RFT 26-083 Interior Renovations & Air Conditioner Upgrades at Frontenac PS

The following, issued by the Halton District School Board (HDSB) June 18, 2026, shall be incorporated in the specifications and shall form part of the proposal document for the above.

TENDER ADDENDUM NO. 1
2026.06.17

Interior Renovations and Air Conditioner Upgrades at Frontenac Public School
Halton District School Board RFT 26-083
5140 Pinedale Avenue, Burlington, Ontario

Drawing No.:
A1.3

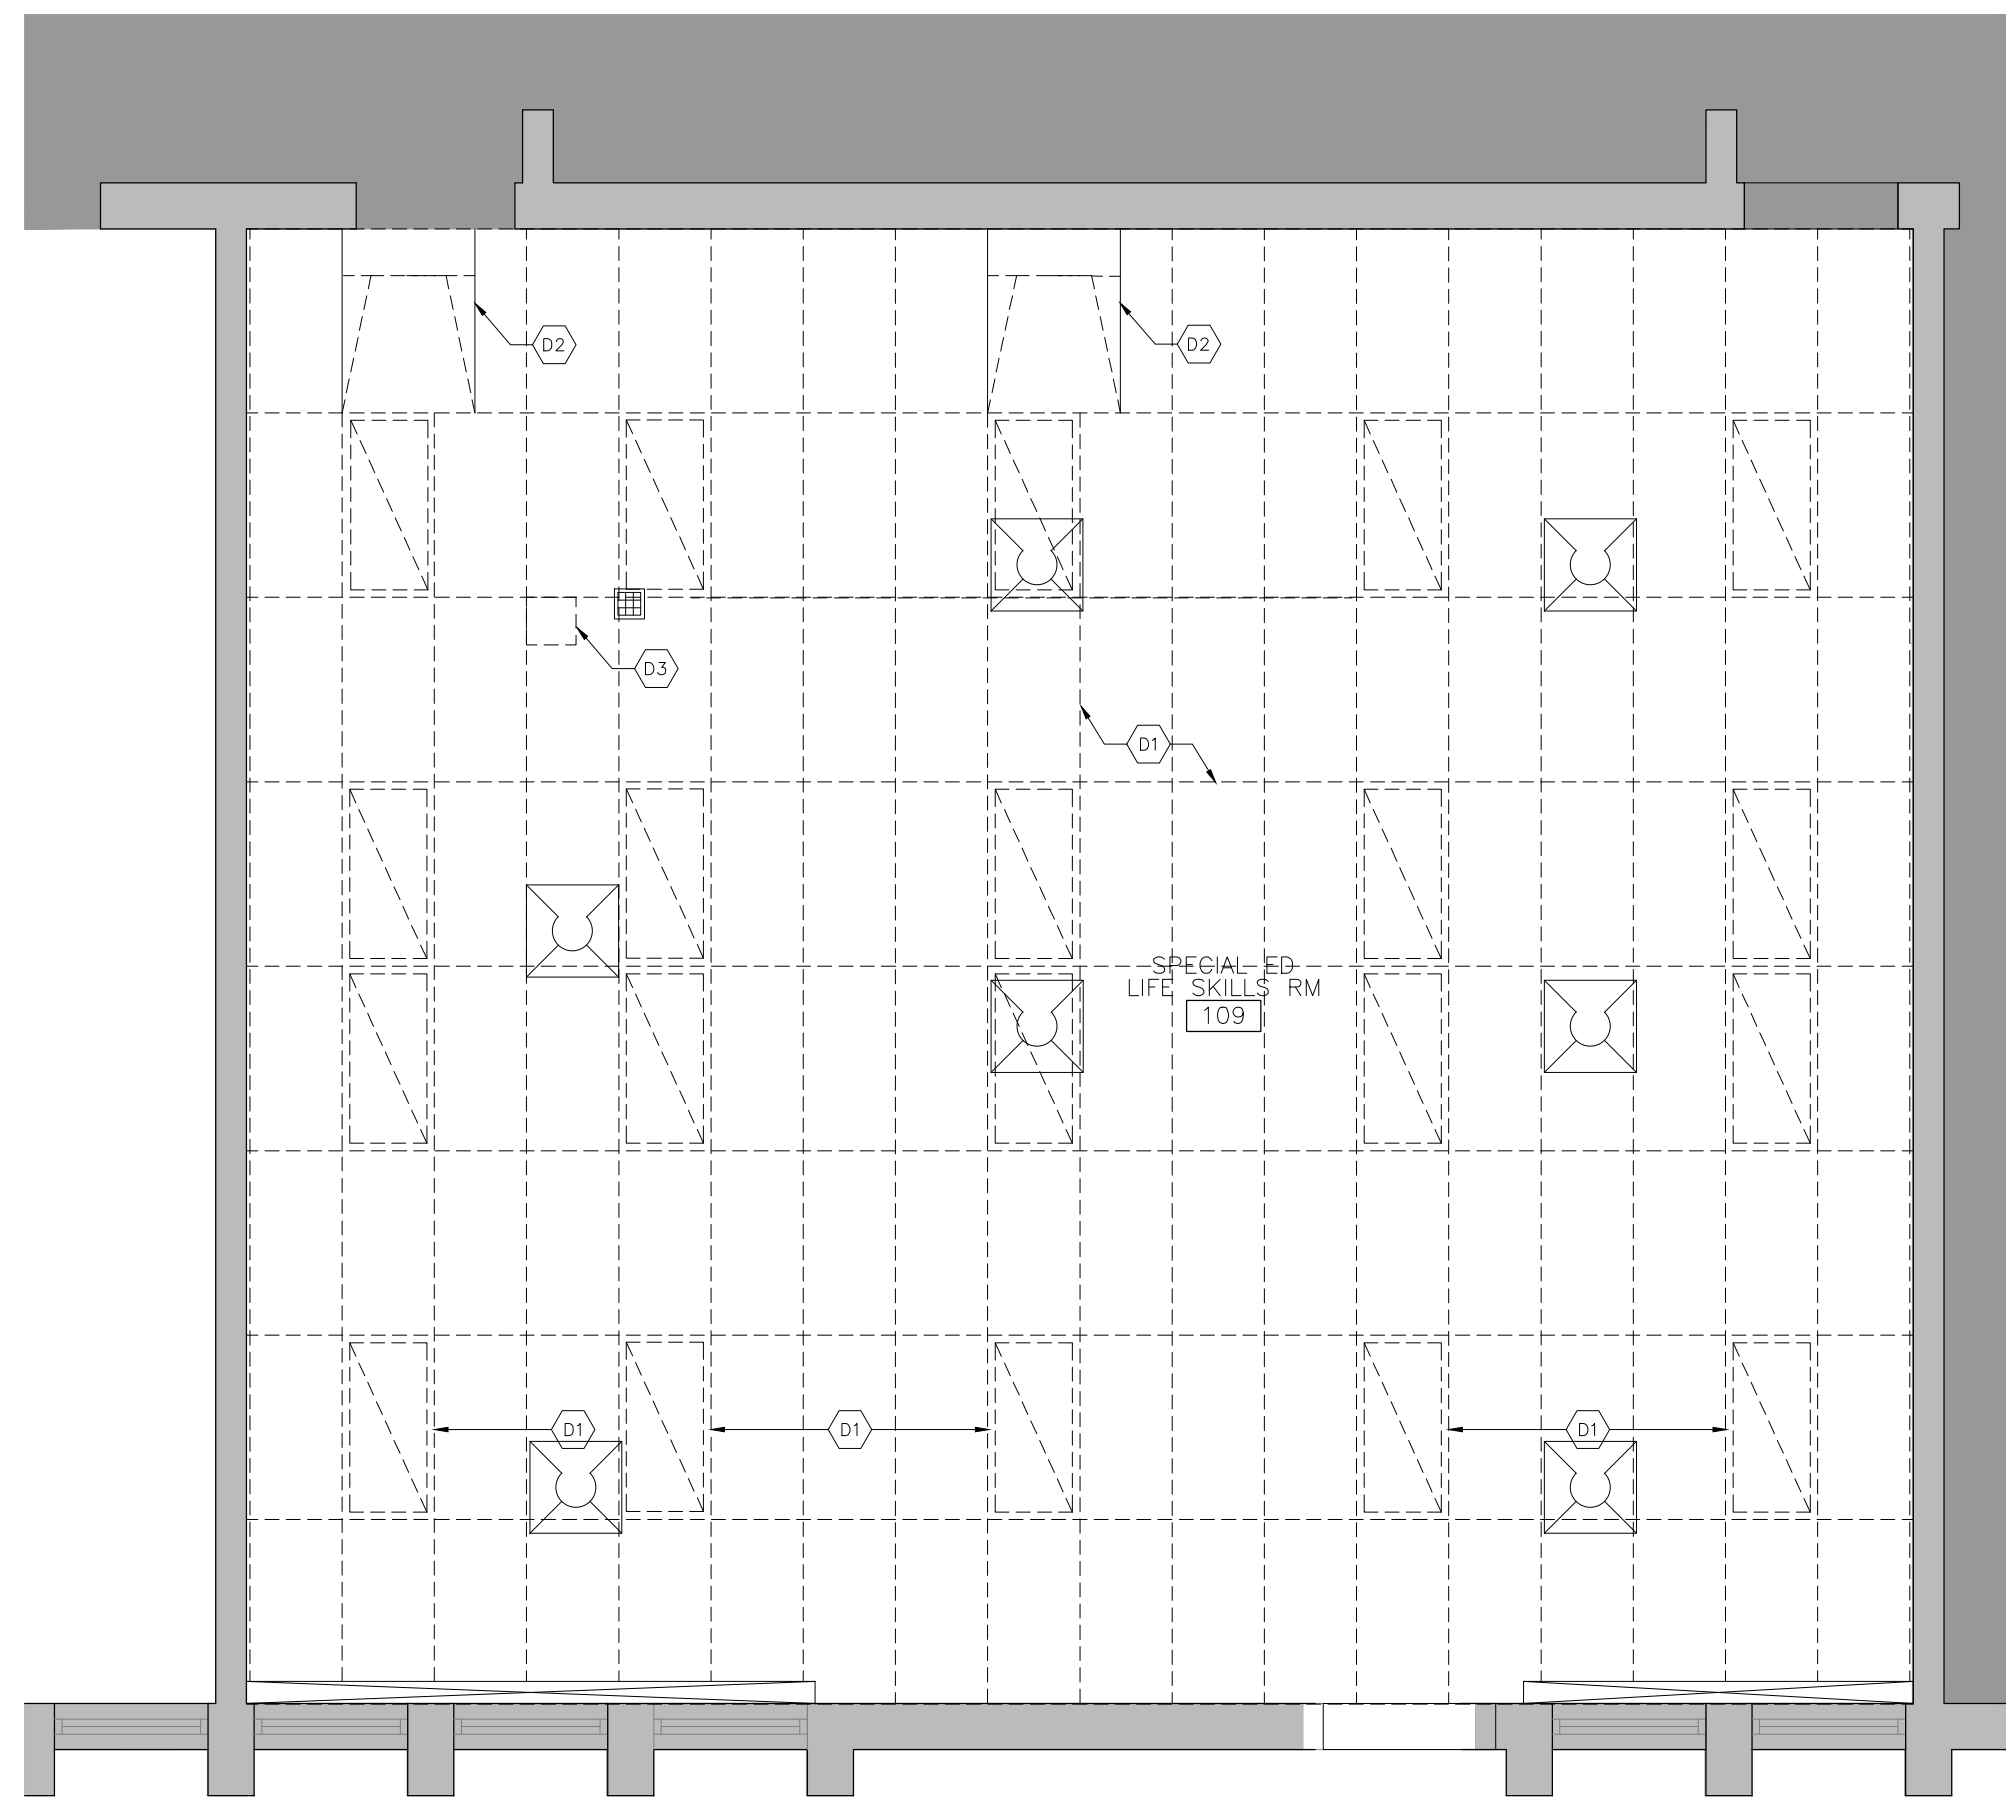
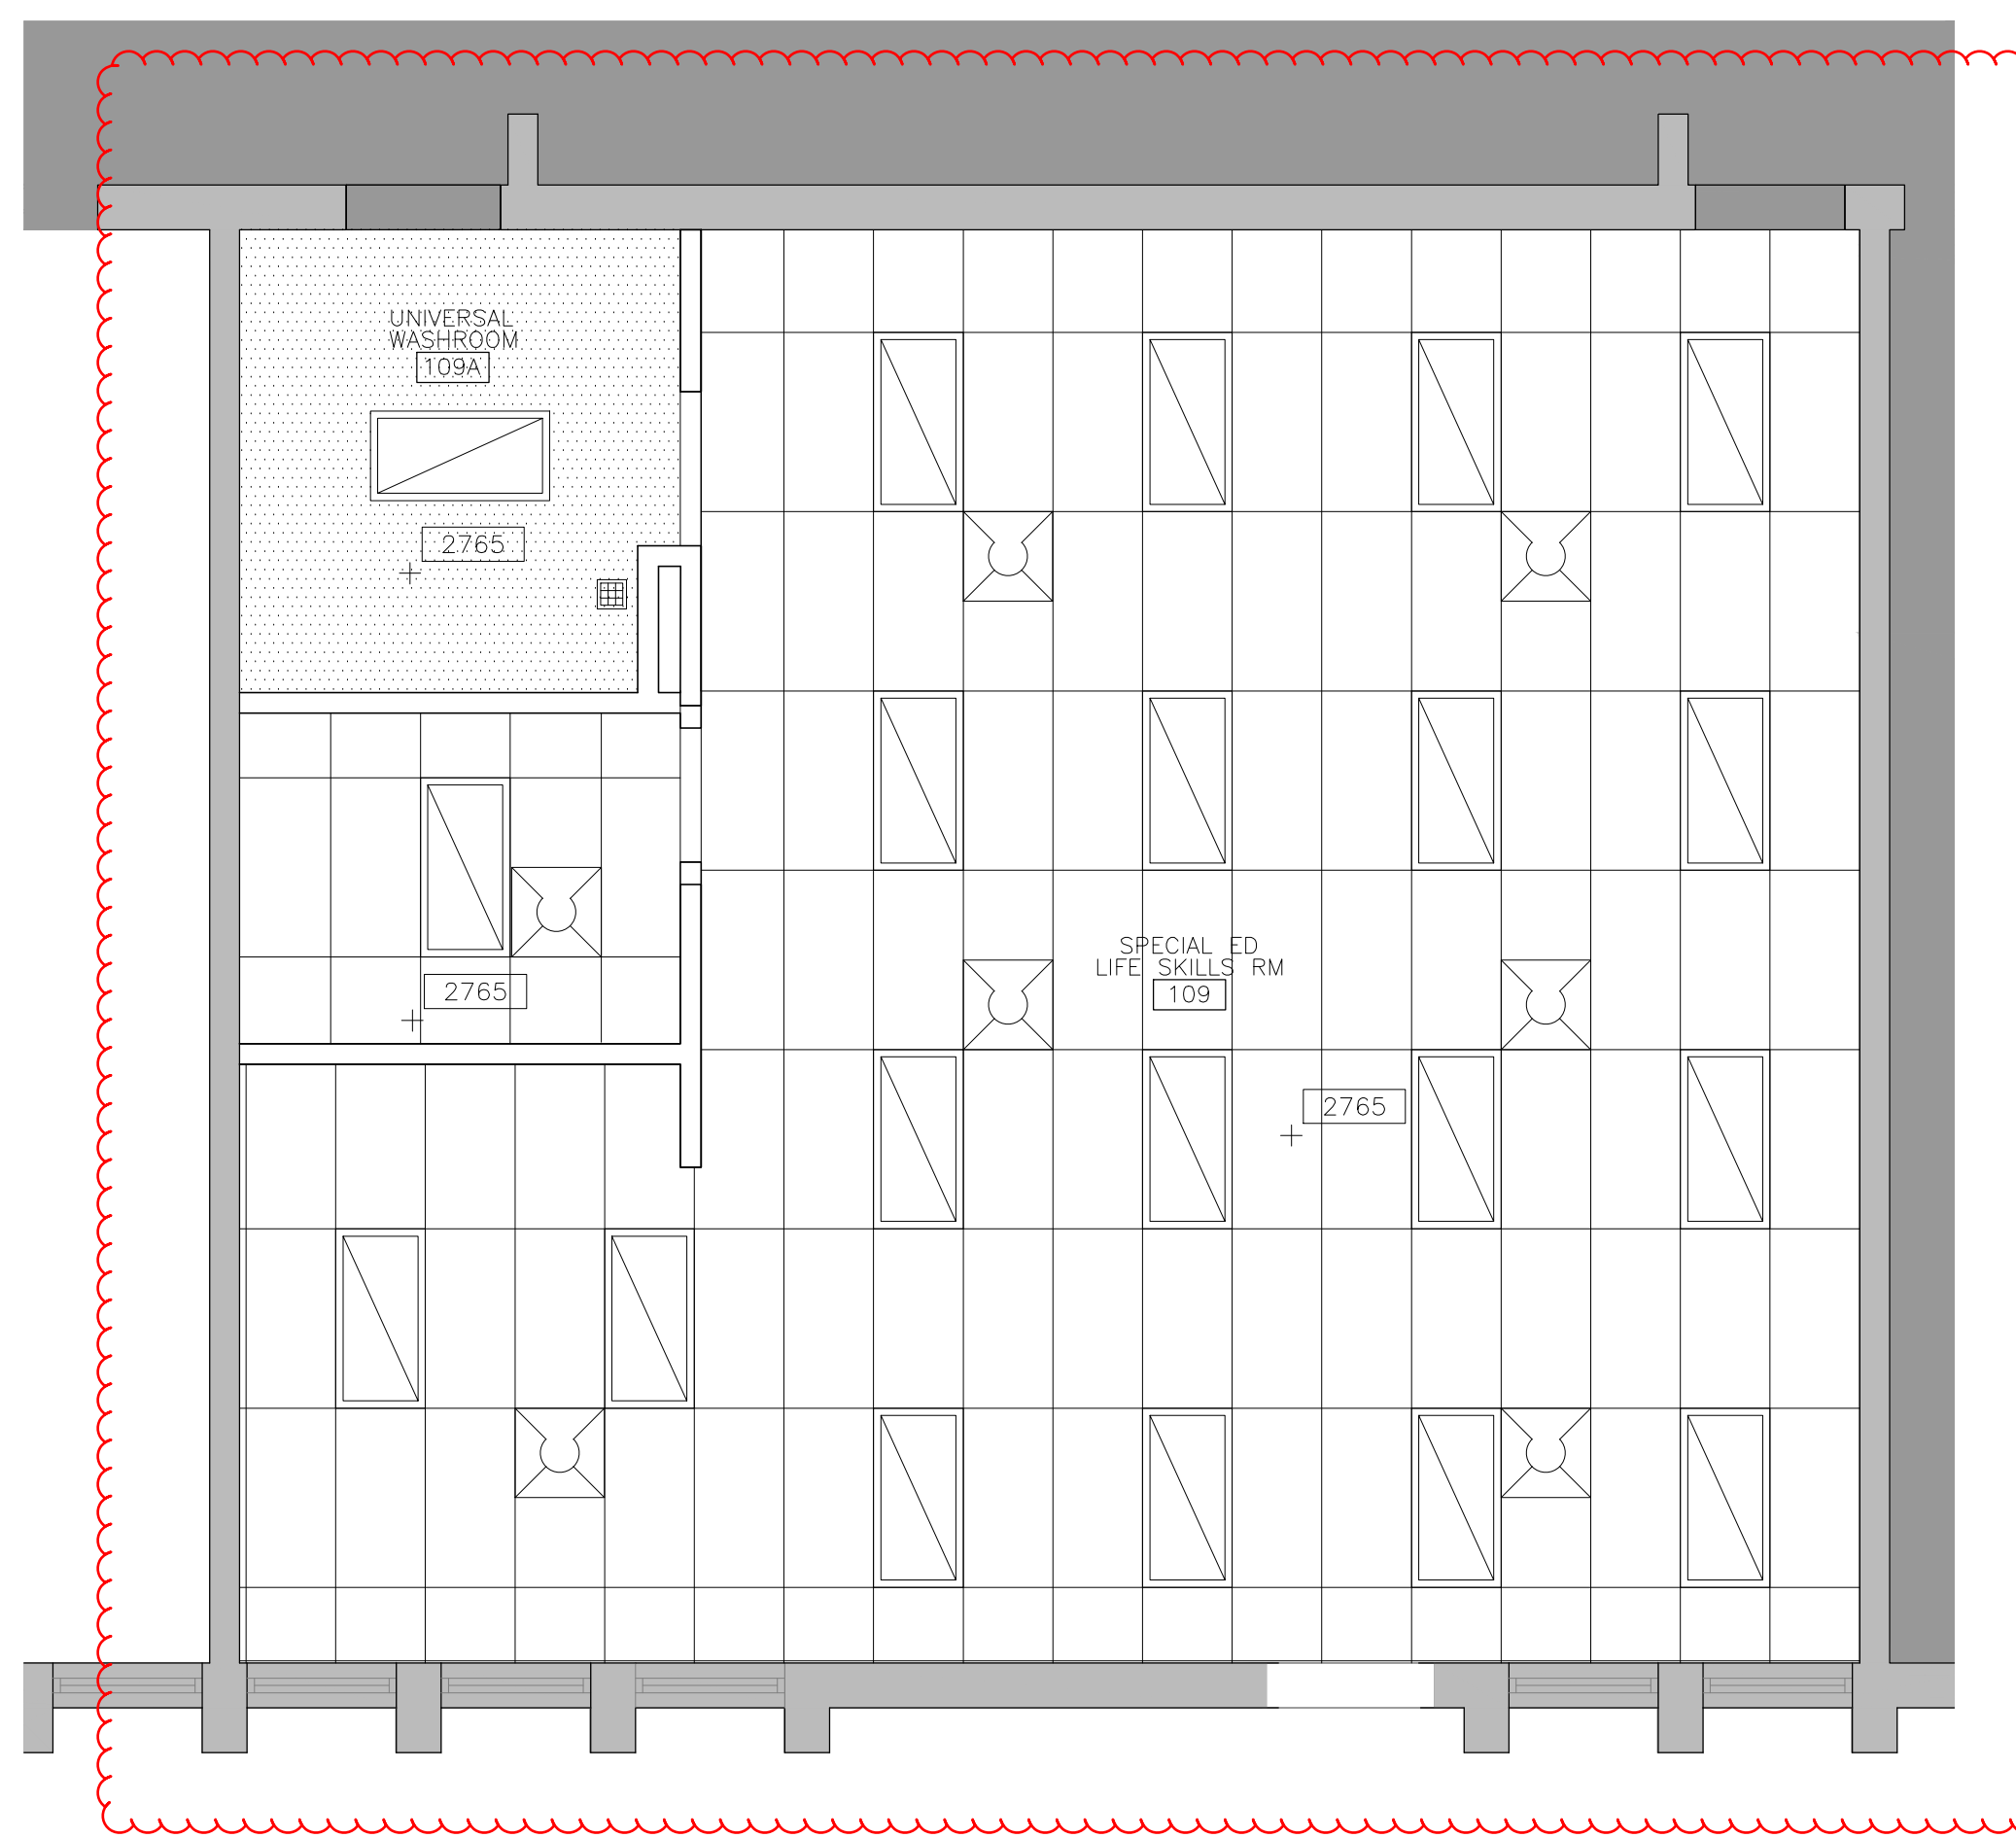
1.5: Drawing A1.3 Demolition & Proposed RCP:

1. ADD to Proposed Reflected Ceiling Plans 2/A1.3 and 4/A1.3 location of HVAC grilles and diffusers. See attached revised drawing A1.3 with bubbled revisions.
